To	Joe Gray – Saddleback Planning
From	Malcolm Todd - Babingtons
Re:	BUN6044955 395 Fitzgerald Rd – S92 Response
Date	9 June 2025

Please see our response to the request for additional information below

PRELIMINARY GEOTECHNICAL INVESTIGATION REPORT

ADDRESS: 395 FITZGERALD ROAD, DRURY, AUCKLAND 2113
(LOT 3 DP 194356).

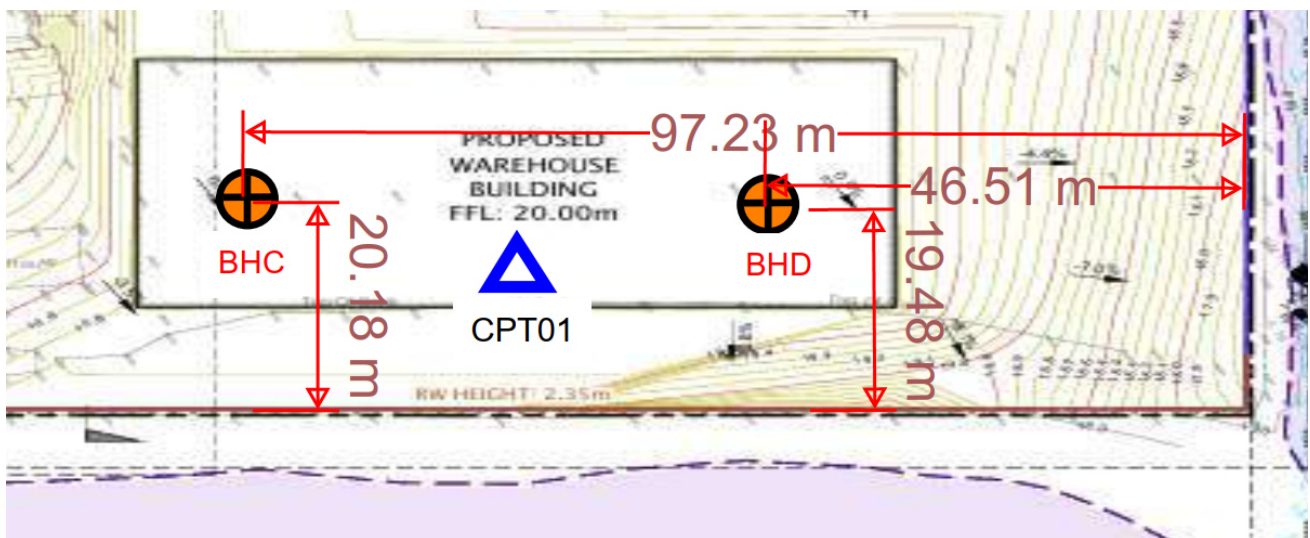
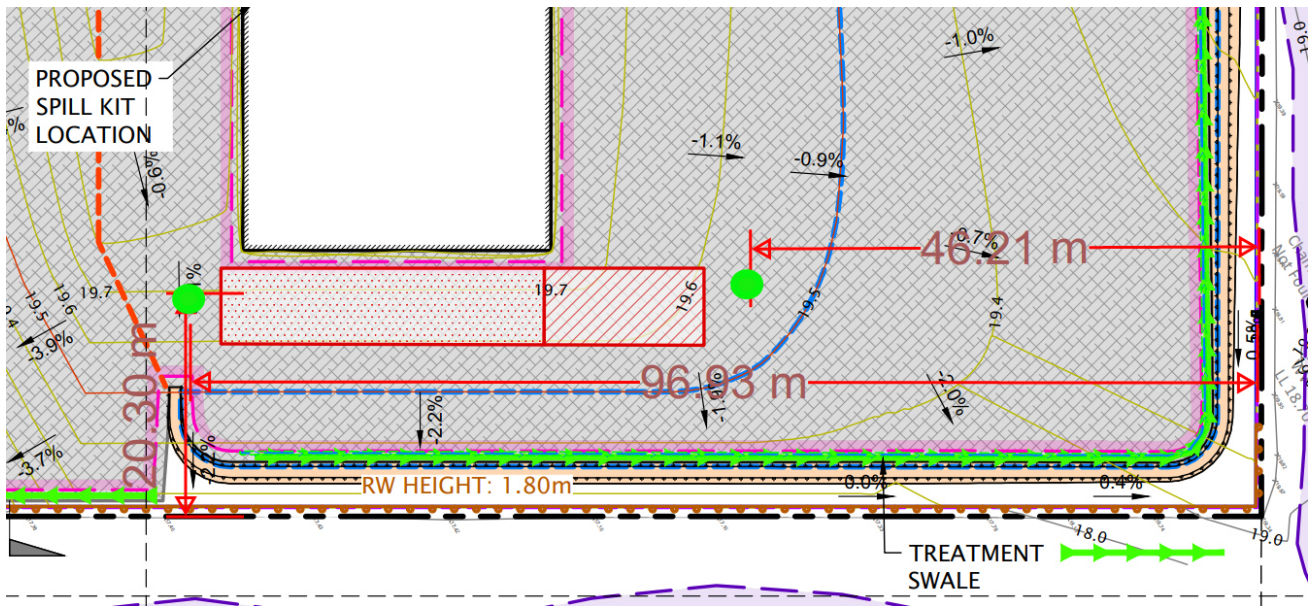
f) Please clarify how the existing stream on site will be protected from adverse effects relating to the proposed use and development on the site.

15. Please provide bore logs for boreholes drilled within the primary and reserve wastewater disposal areas.

The stream will be protected by the provision of full hydraulic neutrality for the new impervious area via the designed discharge control structures. Yard water quality will be addressed by carrying out all dismantling and handling of liquids within the workshop as well as draining all vehicles on arrival to avoid any leakage to the yard surface. Grassed treatment swales and extended detention sedimentation will be provided to remove any further yard contamination sources. This is considered a best practicable option for treatment. Ongoing discharge quality monitoring will be undertaken to ensure compliance with environmental standards is maintained.

Please see the site geotechnical report attached that shows the locations and soil descriptions at borehole locations c and d. Below is snip of these locations relative to the disposal field (green dots). We feel these locations provide sufficient confidence for the soil classification. Please note the Geotech report describes the subgrade as clayey silt and silty clay. We have conservatively assumed a clay subgrade for the entire field.
